UNITED STATES PATENT AND TRADEMARK OFFICE

APPLICATION NO.	FILING DATE	FIRST NAMED INVENTOR	ATTORNEY DOCKET NO.	CONFIRMATION NO.
10/689,472	10/20/2003	Christopher S. Caldwell	RTI-5	7924

Office Action Summary

DETAILED ACTION

FIG. 5

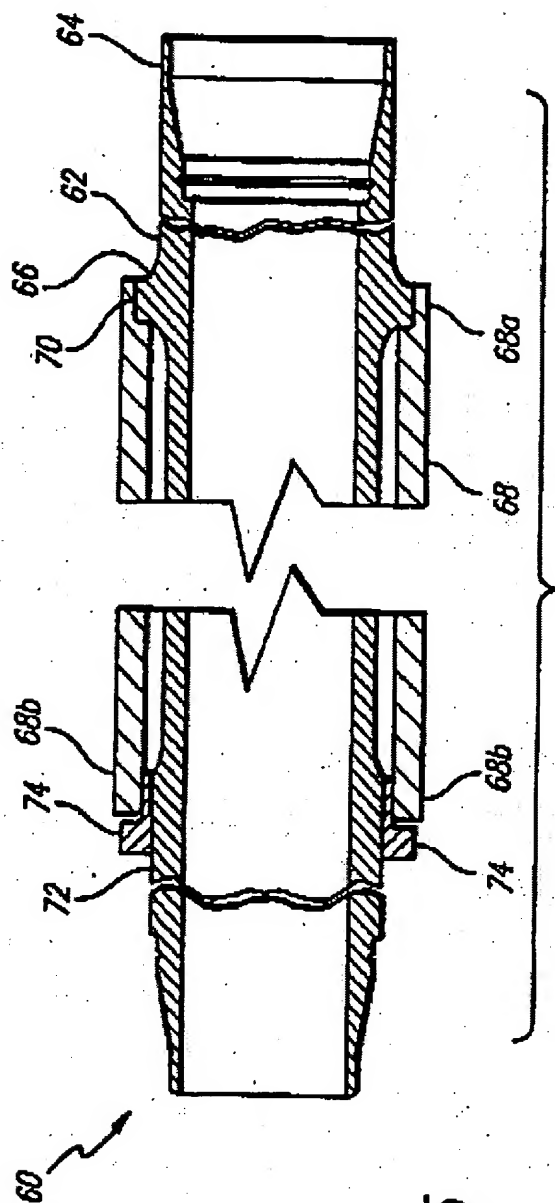
Halkyard '205, as seen in Figure 5, shows a centralizer system (60) comprising:
with regard to claims 1 and 34,

a metallic pipe (62; as admitted by cross section see MPEP 608.02) comprising a pipe outer diameter less than the inner diameter of a receptacle (68) so as to be insertable into the receptacle and relatively moveable within the receptacle (col. 3, lines 28 through 49);

a metallic upset portion (72) formed on said metallic pipe having an upset outer diameter greater than said pipe outer diameter, said pipe and said upset portion being a monolithic structure; and

a metallic centralizer (74; *metallic* as admitted by cross section, see MPEP) in gripping engagement with said upset portion on said metallic pipe whereby said centralizer and said upset are prevented from any relative movement, said centralizer having an outer diameter less than said receptacle inner diameter for insertion into said receptacle;
with regard to claims 2 and 35,

further comprising an upset transition zone on at least one side of said upset portion, said upset transition zone having an outer diameter equal to said upset portion on one end of said upset transition zone such that said outer diameter of said upset transition zone decreases with distance axially away from said upset portion;
with regard to claims 3 and 36,

wherein said centralizer is in gripping engagement with at least a portion of the transition zone (i.e., the end of the transition zone);
with regard to claims 10 and 43,

wherein said centralizer has an outer surface with a curvature portion for contact with said receptacle; and
with regard to claims 11 and 44,

wherein said centralizer has a substantially cylindrical outer surface portion for contact with said receptacle.

Halkyard '205, as seen in Figure 5, fails to teach :

an insulative coating on an outer surface of the centralizer.

With regard to claim 9, it would have been obvious to one having ordinary skill in the art of marine structures at the time the invention was made to modify the device shown by Halkyard '205 in Figure 5 such that the centralizer would include an insulative coating on its outer surface as disclosed by Halkyard '205 in Figures 3 and 4 and in column 3 at lines 7 through 10. The motivation would have been to make the centralizer resistant to wear.
